# STAFF RECOMMENDATION

NCPC File No. 6694

## DWIGHT D. EISENHOWER MEMORIAL

January 27, 2011

Site plan of Maryland Promenade concept (Alternative #2)

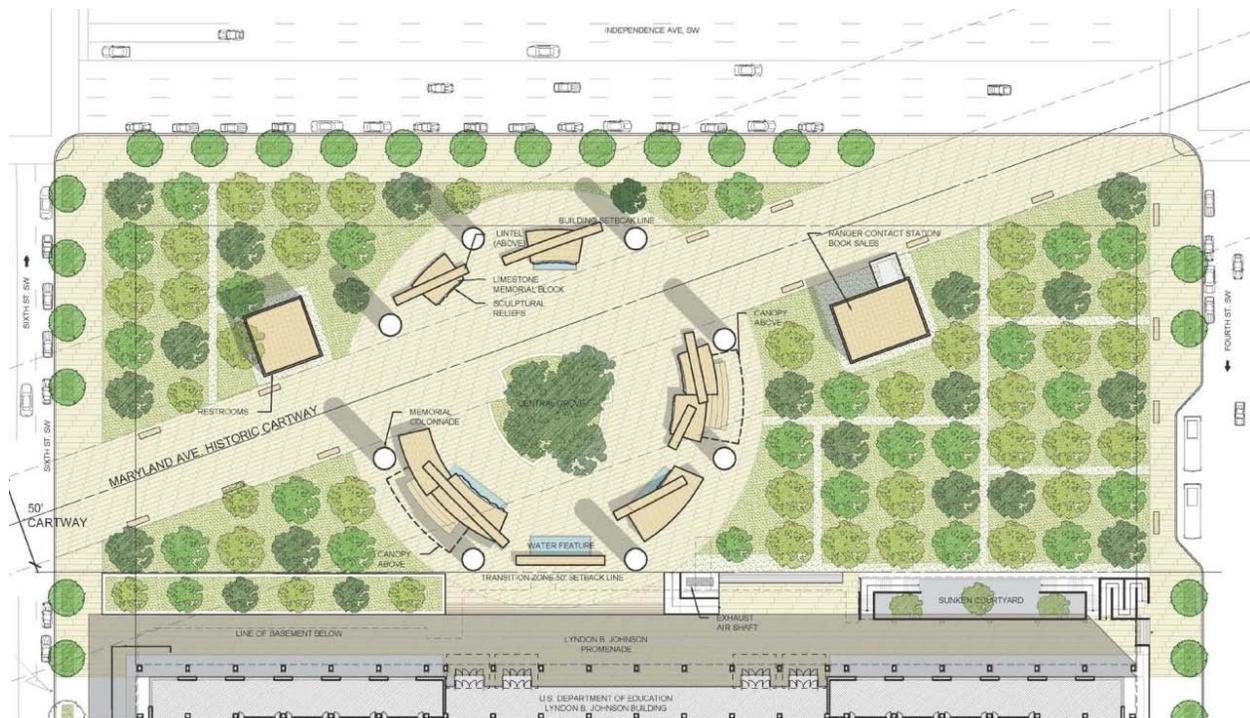
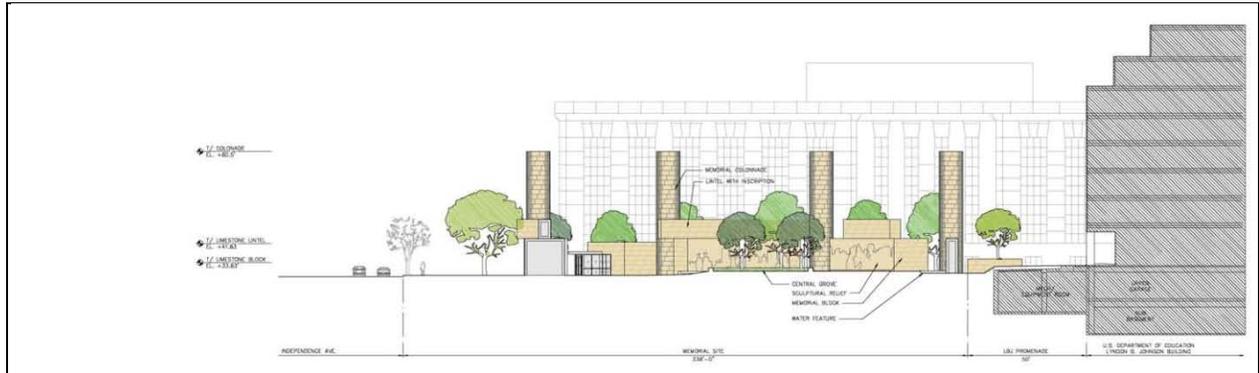
Overall, the treatment of Maryland Avenue and the size of the memorial elements in this alternative successfully create a unified memorial site that integrates the disparate parcels into a meaningful and functional gathering place that also unifies the surrounding precinct by providing a new central green space upon which the surrounding buildings can organize around. In addition, by establishing a new Presidential memorial and landscaped square the concept design would also position the site as one in a sequence of public spaces along the Maryland Avenue vista including the U.S. Capitol grounds, historic Reservation 113, and the Jefferson Memorial. The concept is also consistent with the design principle pertaining to the need to respect existing building lines in how the memorial elements are organized on the site. The central grove, colonnade, stone block sculptures and lintels are all located at or behind the building lines along Independence Avenue, 4<sup>th</sup> Street, and 6<sup>th</sup> Street. These elements also respect the alignment of trees along Maryland Avenue.

The alternative reflects the principles of the L'Enfant Plan as they pertain to the relationship of public squares to avenues, and to the shaping of public spaces by the buildings that surround them. By closing Maryland Avenue to vehicular traffic, the Maryland Promenade concept successfully creates a cohesive public square that reads as a separate and distinct public gathering space that is defined by the surrounding buildings. The concept design also respects and complements the architecture of the surrounding precinct by relying upon it to define the space rather than trying to compete with or marginalize it. This is especially true of the

Department of Education building where under this alternative is provided with an improved entry forecourt and renewed presence along Independence Avenue. Finally, this particular concept incorporates significant green space into the design of the Memorial by establishing areas of greensward that frame and accentuate the Memorial core and the Maryland Avenue cartway. The greensward areas will be planted with a consistent canopy of deciduous trees which will provide a uniform canopy and further add to the greening of the site.

better to the overall composition of the viewshed along Maryland Avenue, and through further refinement to their placement could establish an appropriate foreground to the view of the Capitol Building. Furthermore, the placement of the memorial support buildings at the edge of the cartway is problematic from the standpoint of preserving the viewshed along Maryland Avenue, as is the slight intrusion of the Memorial's central grove. As support facilities of the Memorial, the buildings need not be located so prominently within the historic viewshed. In addition, buildings would not typically be allowed to be located inside the 160-foot right-of-way. Therefore, staff recommends that these buildings be relocated, and possibly consolidated, to a more discrete location on the site outside of the Maryland Avenue right-of-way.

Regarding the need to preserve reciprocal views to and from the U.S. Capitol along Maryland Avenue, staff notes that while an improvement from the previous concept design this alternative also needs refinement in order to satisfy this design principle. This alternative proposes columns that are 10-feet wide by 50-feet high, 18 feet lower than in Alternative #1. The lower columns seem to relate

Site plan of Maryland Park concept (Alternative #3)

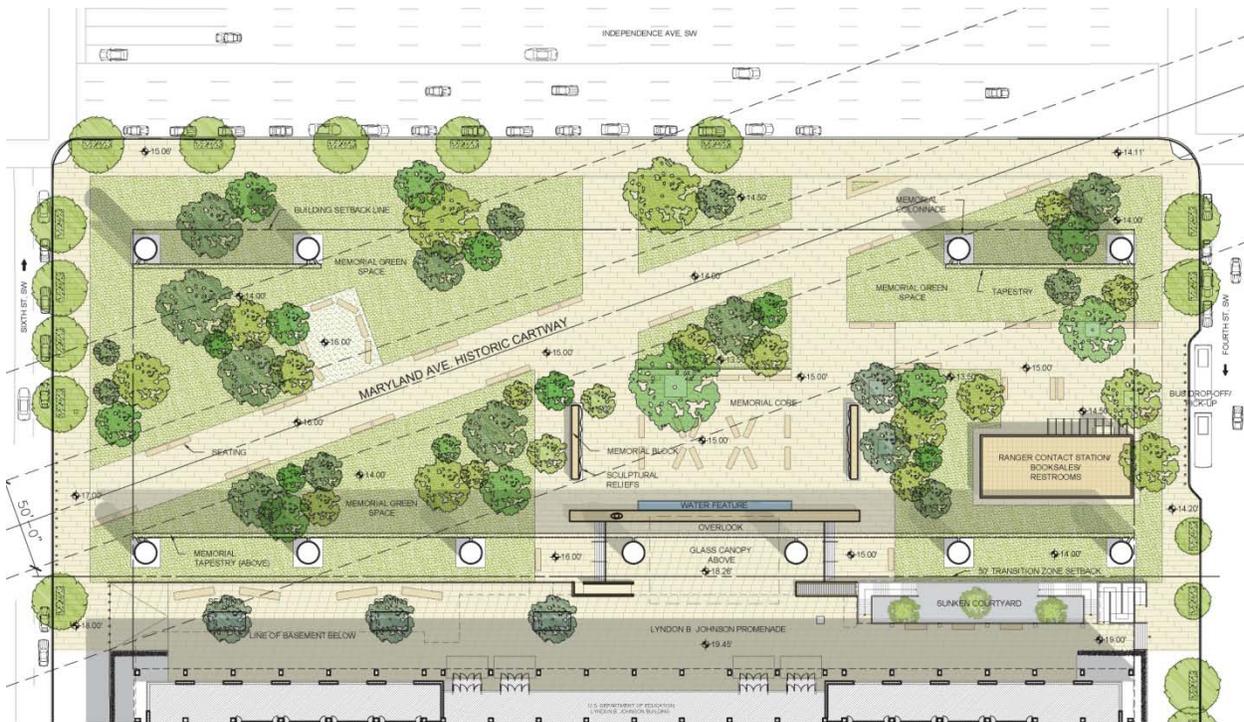
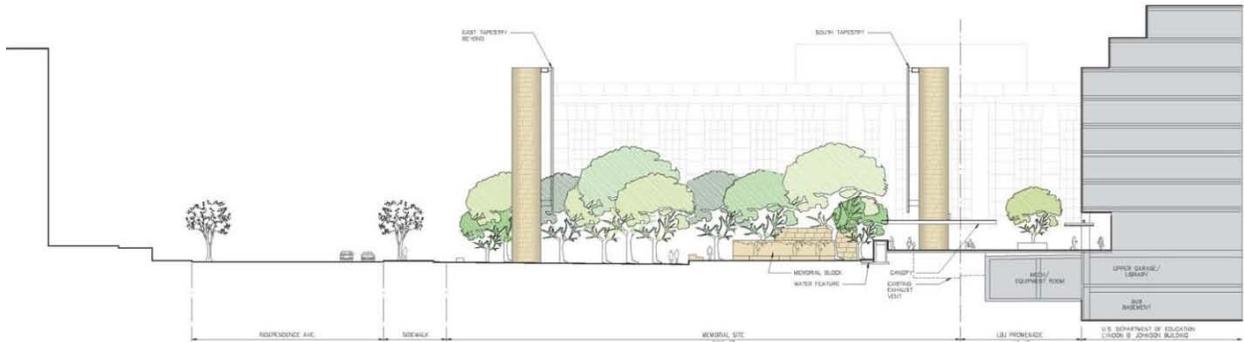
Like the previous two alternatives, the Maryland Park alternative also unifies the site's collection of disparate parcels into a unified memorial site. The use of the stainless steel tapestries along the north and south sides of the site create an autonomous, stand alone precinct within which the memorial elements are located. The configuration of the tapestries has been influenced by the notion of building an object within a temple within a picturesque landscape, likened to the Lincoln Memorial. In addition, the tapestries take the form of a proscenium stage, with the south tapestry as the backdrop, upon which the story of Eisenhower can be told when viewed from Independence Avenue. In addition, the design concept creates a unique public gathering space that establishes the site as one in a sequence of public spaces along the Maryland Avenue vista. Significant green space is also proposed for along the ground plane and through a diverse landscape plan that proposes a more irregular arrangement of vegetation intended to reflect a

While staff finds that the Maryland Park alternative creates a unified memorial site and public gathering space, it cannot find that the proposed concept design unifies the surrounding precinct. The placement of the tapestries along the north and south edges of the site essentially establishes walls that define a self-contained memorial precinct, with the exception of the proscenium stage view along Independence Avenue. The applicant's efforts to create a memorial precinct in the image of the Lincoln Memorial does not

translate into a memorial that reads as an object, within a temple, within a picturesque landscape. Instead, the tapestries, analogous to the walls of the temple, have been pushed to the outer edges of the site forcing the actual landscape to be located inside of the memorial precinct, with the landscape imagery of the tapestry serving as the surrounding picturesque landscape. This results in a memorial design that essentially turns its back on the surrounding precinct, especially the Department of Education building, rather than creating a common space which the surrounding buildings help to define. Specific to the Department of Education, the size and placement of the tapestries will overshadow the LBJ Building and eliminate its chances to participate fully in the definition of this new urban square. In addition, irrespective of the level of transparency ultimately attained, the placement of a 78-foot high, 550-foot wide structure supported by columns that are nine to twelve feet in diameter will have a detrimental effect on the quality of the working environment of Department of Education employees, specifically with respect to natural light and views. In staff's judgment, the concept also does not respect and complement the architecture of the surrounding precinct other than taking cues from the height and scale of the surrounding buildings to design memorial elements such as the tapestries and supporting colonnade. Staff would consider this appropriate if the site was to be developed with a building as opposed to the public open space envisioned by the design principles.

Regarding the design principles that address the need to respect the building lines of the surrounding rights-of-way and reflect L'Enfant Plan principles by shaping the Memorial site as a separate and distinct public space, the applicant has indicated that the tapestries create or help to reinforce the street wall, particularly along Independence Avenue. However, as can be seen at any other square throughout Washington, as one approaches the square the defined street wall gives away to an open space that is defined by the surrounding buildings. When commenting on the 2006 design principles DC SHPO stated "it is the shaping of view corridors and public spaces

The Maryland Park alternative also compromises the reciprocal views to and from the U.S. Capitol along Maryland Avenue by placing columns and portions of the tapestries within the 160-foot right-of-way in a manner that dominates views to the Capitol. While the applicant has made minor modifications to

the tapestries as they relate to the viewshed and the LBJ Building, staff recommends that they still disrupt views of the U.S. Capitol given their proposed size and placement. The placement of the columns and tapestries also reframes the viewshed in a way that is visually off center and disrupts the visual perspective converging on the Capitol. The east-west orientation of the tapestries also takes away from the avenue being read as the dominant element over the orthogonal street grid, a basic L'Enfant Plan principle.

View of southern portion of Memorial core with Maryland Avenue in the foreground

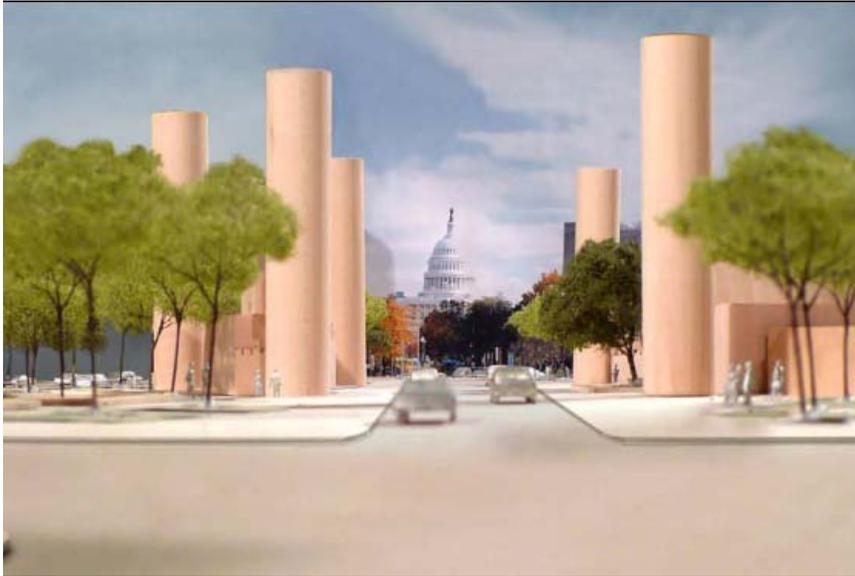
Although the concept design integrates the disparate parcels into a unified memorial site, with the central grove, stone block sculptures, and surrounding colonnade in the middle of the site providing a strong yet modest commemorative focal point, the presence of the roadway bisecting the Memorial's core into two parts would likely dominate the space and impede the ability to establish a public gathering space that is meaningful and functional due to traffic queuing and noise. The presence of the roadway would also likely detract from the success of the Memorial as a place to reflect and learn about President Eisenhower. Furthermore, with the roadway bisecting the site there is potential for vehicle/pedestrian conflicts to occur as a result of visitors attempting midblock crossings while circulating within the Memorial core. The roadway would also diminish the ability of the Memorial to unify the surrounding precinct by interfering with the creation of a unified landscape upon which the surrounding buildings can organize around. Finally, while a marked improvement from what currently exists on the site, staff finds that this alternative could do more to maximize the amount of green space provided, especially considering the amount of impervious surface that currently exists on and around the site including the Maryland Avenue roadway. In the spirit of designing this space to function as a standalone Presidential Memorial within a surrounding landscape, staff recommends that the applicant increase the use of vegetation along the ground plane. Doing so would further distinguish this site from the hustle and bustle of the surrounding urban environment. It would also help dampen traffic noise along Maryland and Independence Avenues, and establish a more informal setting outside of the Memorial core for visitors to enjoy.

Regarding views, in staff's judgment the Maryland Roadway concept does not go far enough to preserve reciprocal views to and from the U.S. Capitol along Maryland Avenue. For example, five of the eight columns that encircle the central grove are located within the historic 160-foot

right-of-way, and four of them are located directly on the edges of the proposed 50-foot cartway. At 68-feet high and 10-feet in diameter, these columns would dominate the viewshed along the avenue towards the Capitol Building. While it was previously determined during site selection that the 50-foot cartway would be recognized as being completely off limits to any physical memorial elements, the actual historic viewshed encompasses the entire right-of-way. Therefore, the placement of any memorial elements within the right-of-way must be done sensitively so as

not to compromise the integrity of the historic view toward the Capitol. As stated earlier, staff considers the scale of the columns to be appropriate and effective in defining the Memorial space within the larger site and surrounding context. In this instance, it is the placement of the columns in such close proximity to the cartway that is problematic.
